BG #: 13-133 Change Order No.: 003

Project: GC Burkhead Elementary School Time Extension Required: ☐ Yes ☒ No If yes, by \_\_\_\_\_ day(s)

Change Order Description and Justification:	Cost Benefit to Owner:
Media Center lighting revision.

MEDIA CENTER LIGHTING REVISIONS  
G.C. BURKHEAD  
ELEMENTARY SCHOOL  
BG# 13-133

**XE03**

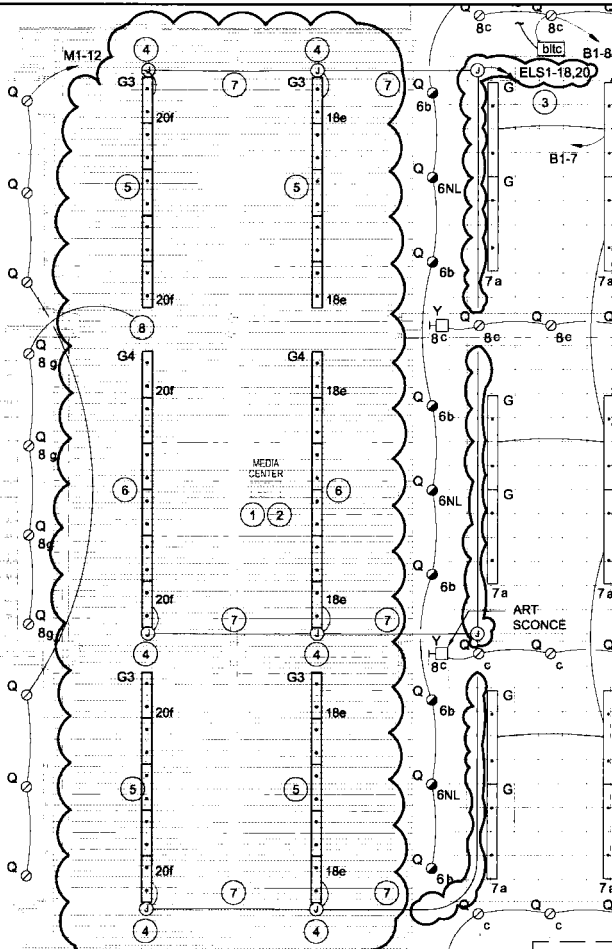
Refer to attached Sketch XE03:

Omit lighting fixtures and electrical items indicated on Sketch XE03 - revise circuitry and layout as indicated. Manufacturer has confirmed that Type G3 and G4 light fixtures are available through a quick ship program for 5 business day delivery. Contractor shall selectively route conduits to minimize visibility as much as possible – paint to match adjacent surfaces. All penetrations through wood trusses shall be approved by the truss manufacturer and comply with their requirements.

#	
1	OMIT (14) TYPE "O" LIGHT FIXTURES, ASSOCIATED LABOR, CIRCUITRY, CONDUIT, WIRING, BLTC AND SWITCH "e" - APPLY APPLICABLE CREDIT TO PROPOSAL.
2	OMIT (12) TYPE "Z" LIGHT FIXTURES, (6) TYPE "Z1" LIGHT FIXTURES, DIMMERS "d" AND "f", ASSOCIATED LABOR, CIRCUITRY (B1-9,10), CONDUIT AND WIRING, BACK TO SOURCE PANEL "B1" - APPLY APPLICABLE CREDIT TO PROPOSAL. BREAKERS SHALL BECOME "SPARES".
3	EXTEND 1/2" C WITH #12 AWG TO PANEL ELS1 ON PLATFORM 601A, NEAR PANEL "B1" - FURNISH AND INSTALL (2) 1P20A CIRCUIT BREAKERS AND CONNECT. FURNISH AND INSTALL NEW SWITCHES "a" AND "f" TO CONTROL LIGHTING CIRCUITS ELS1-18,19. SWITCHES SHALL BE GANGED WITH SWITCHES "a" THROUGH "d", NEAR CIRCULATION DESK. FOR SWITCHES "a" AND "f", FURNISH AND INSTALL A SHUNT RELAY FOR EACH, EQUAL TO LIGHTING CONTROL AND DESIGN #RG2001-E/S - WIRE PER MANUFACTURER'S RECOMMENDATIONS.
4	EMERGENCY POWER FEED DROP TO SUSPENDED ROW OF LIGHTING - COORDINATE EXACT PLACEMENT WITH WOOD PURLINS - SLIGHT RELOCATION IS PERMITTED.

5	LIGHT FIXTURES SHALL BE SUSPENDED WITH BOTTOM AT 112'-8". COORDINATE SUSPENSION CABLE LENGTH AND FINAL ANCHOR POINTS INTO WOOD DECKING. LIGHT FIXTURE ROW "G3" SHALL BE PEERLESS #10CRM4-QST-228T5-20/80-WHR-X24-R4-120-SCT-LP841-F2-C210-ACG WITH 80% DOWNLIGHT AND 20% UPLIGHT.
6	LIGHT FIXTURES SHALL BE SUSPENDED WITH BOTTOM AT 117'-0". COORDINATE SUSPENSION CABLE LENGTH AND FINAL ANCHOR POINTS INTO WOOD DECKING. LIGHT FIXTURE ROW "G4" SHALL BE PEERLESS #10CRM4-QST-328T5-20/80-WHR-X24-R4-120-SCT-LP841-F2-C210-ACG WITH 80% DOWNLIGHT AND 20% UPLIGHT.
7	BORE BEAM FOR 1/2" CONDUIT PASS THROUGH - COORDINATE WITH TRUSS MANUFACTURER FOR APPROVAL FOR MEANS AND METHODS. ALL EXPOSED CONDUIT SHALL BE PAINTED TO MATCH DECKING, TO THE SATISFACTION OF THE ARCHITECT.
8	CONNECT TO CIRCUIT B1-8, IN LIEU OF B1-10.
